Illinois Power Company

Subject: Clinton Power Station Unit 1
SER Outstanding Issue #3 (NUREG-0853)

RESPONSE TO NRC REQUEST FOR FURTHER CLARIFICATION ON
THE SOIL AMPLIFICATION ISSUE

Figure 1: Comparison of Weighted Response Spectrum Amplification Curves Using SHAKE Procedure and Random Vibration Method

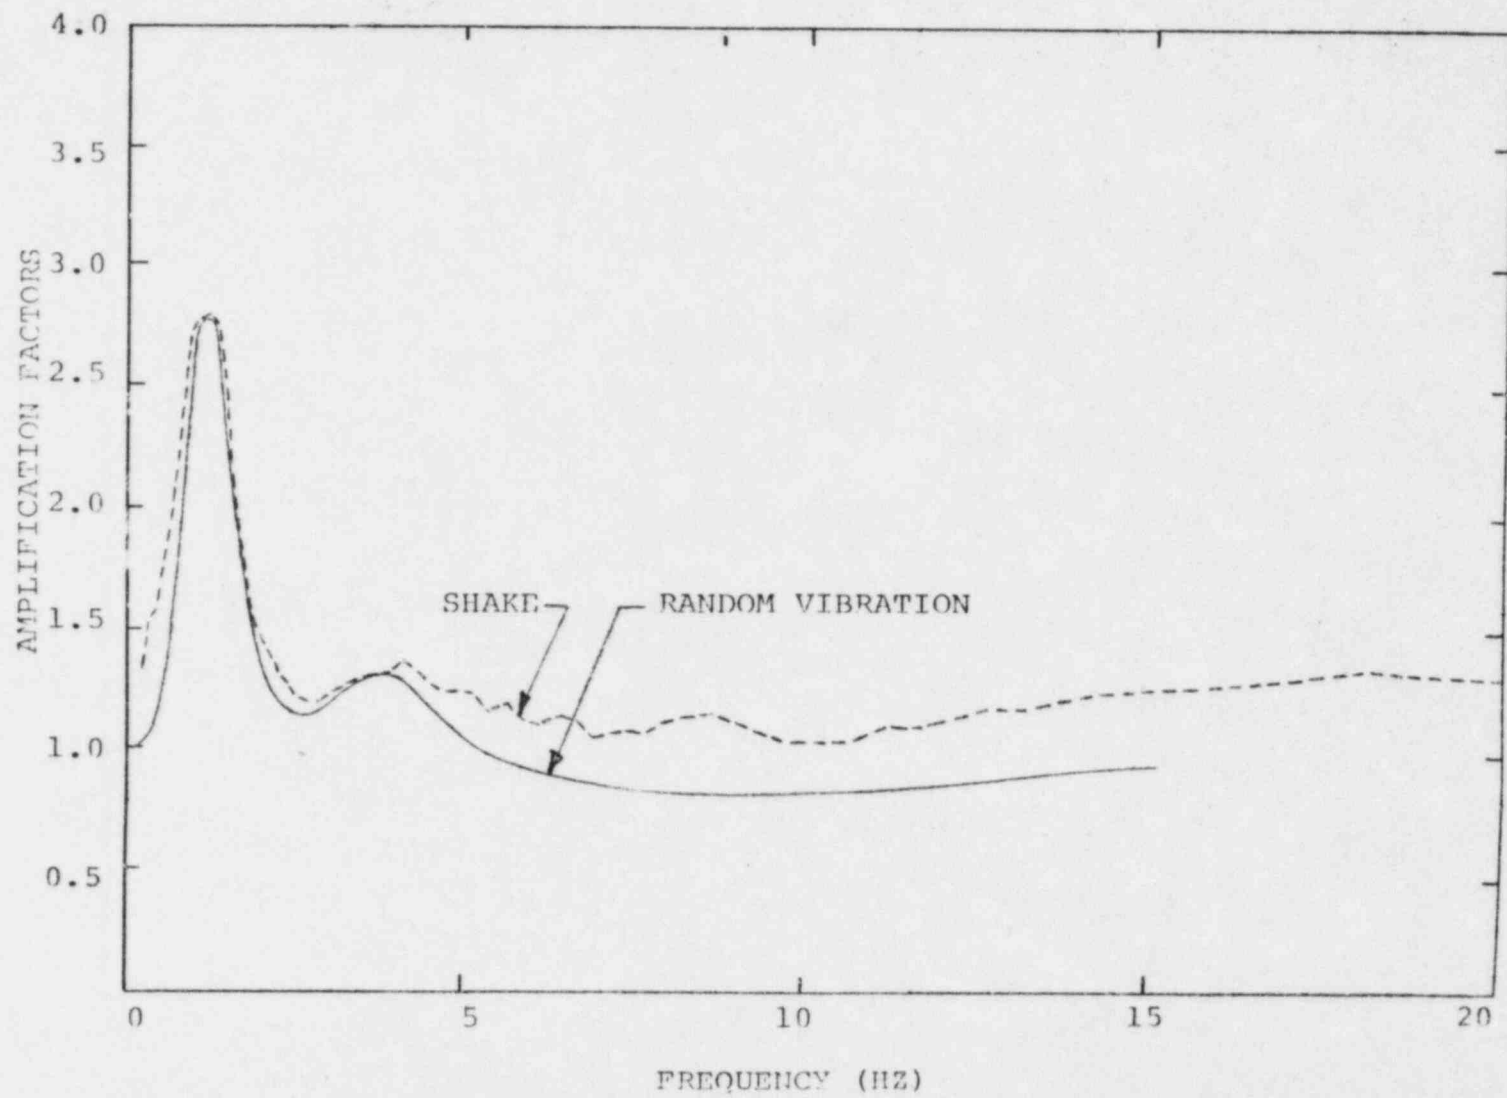
"However, the staff has noted that the "weighted average" amplification peaks are considerably lower than the peaks on the "mean soil property" amplifications curve (Figure 1). In the case of the amplification factors obtained from the SHAKE program, the "weighted average" peaks fall outside (below) the range of peaks predicted by the range of soil properties (upper/lower bound) assumed for the site (Figure 2). In past safety reviews the NRC has recommended a conservative approach in enveloping the effects of soil amplification if uncertainties existed.

Therefore, we request that you discuss the resulting fluctuations in the theoretical soil design spectrum caused by assuming a range of soil properties. Subsequently you should justify, statistically or otherwise, the use of the weighting procedure referred to earlier in this letter in light of past NRC positions....."

For the Clinton site specific spectra report, (Reference 3), the response spectrum amplification factors were computed by Dr. Vanmarcke using a random vibration approach. For the present statistical evaluation the services of Dr. Vanmarcke were not available in a timely manner and the alternate SHAKE program procedure was used. To establish the validity of the SHAKE procedure a mean plus one standard deviation amplification curve was generated for upper bound, mean and lower bound soil property (Table 1) using the fourteen different rock motions (Table 4) and

computing the ground surface spectra resulting from these rock motions. The mean plus one standard deviation amplification curve was generated for each soil property using the fourteen sets of amplification factors. The weighted average of the mean plus one sigma response spectrum amplification was obtained by assigning 25%, 50% and 25% weights to upper, mean and lower bound soil properties. Figure 1 compares the 84th percentile response spectrum amplification factors obtained from the SHAKE procedure to the corresponding amplification factors obtained by Dr. Vanmarcke using random vibration method. It can be observed that the two procedures yield very similar results with the SHAKE procedure giving slightly more conservative results at higher frequencies.

Figure 4: Comparison of Design Basis Time History Spectrum to Theoretical Spectra Considering Soil Amplification

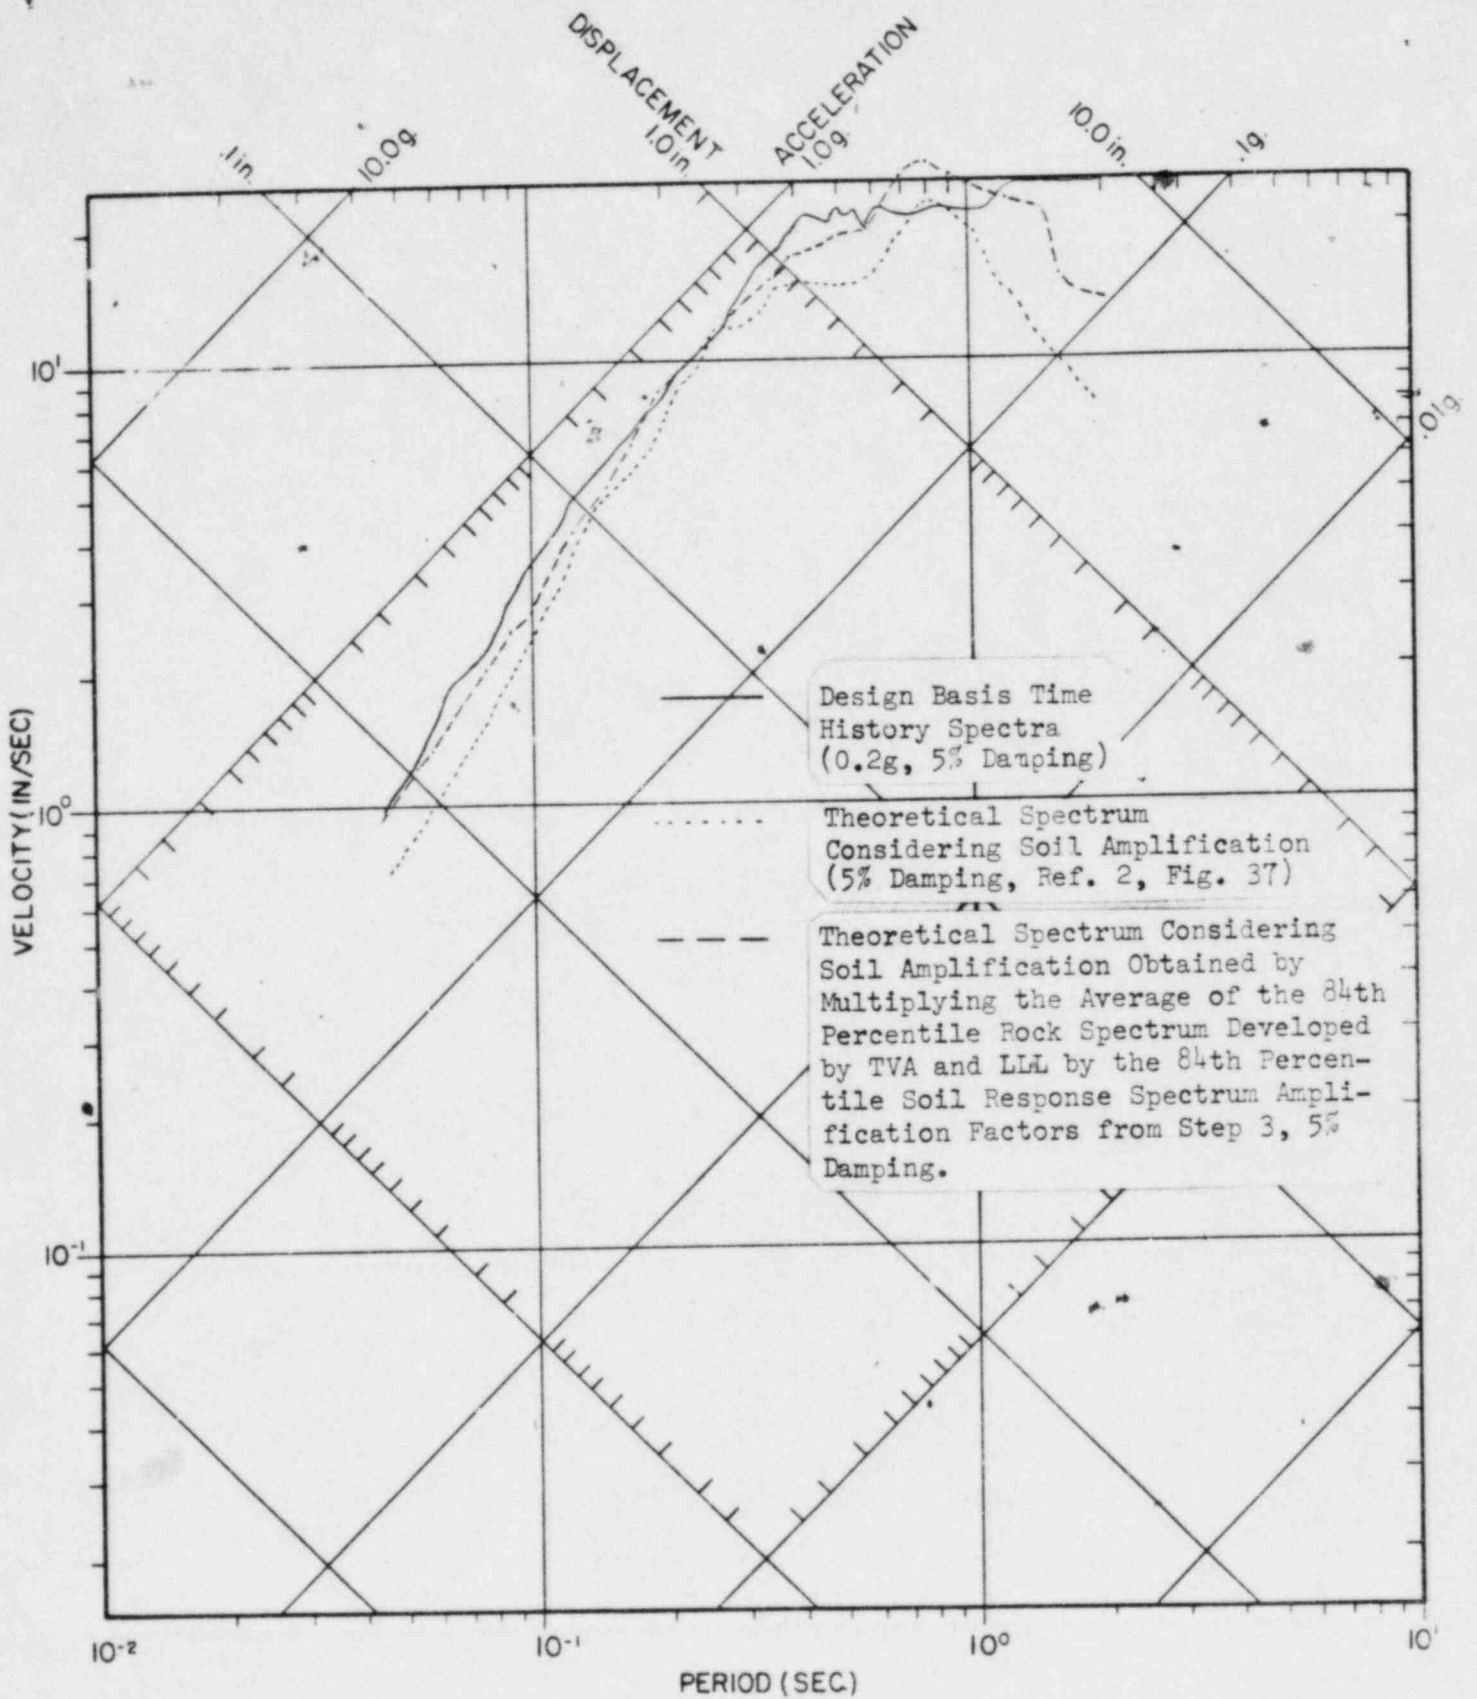
This is in reply to the referenced letter and the request by
Mr. G. Giese-Koch in the telephone conference with NRC, IP and
S&L on March 1. Enclosed is the document entitled, "Response to
NRC Request for Further Clarification on the Soil Amplification
Issue." Figure 4 of our response gives the additional information
verbally requested by Mr. Giese-Koch in the March 1 telephone
conversation.

Figure 4 presents the comparison of the Clinton design time history spectrum to the theoretical surface spectrum obtained by multiplying the average of the 84th percentile 5.8 magnitude rock site spectrum developed by TVA and LLL by the 84th percentile soil response spectrum amplification factors obtained in Step 3 above. It can be observed from the figure that the design spectrum envelopes the theoretical surface spectrum at all frequencies significant to the systems and structure design.
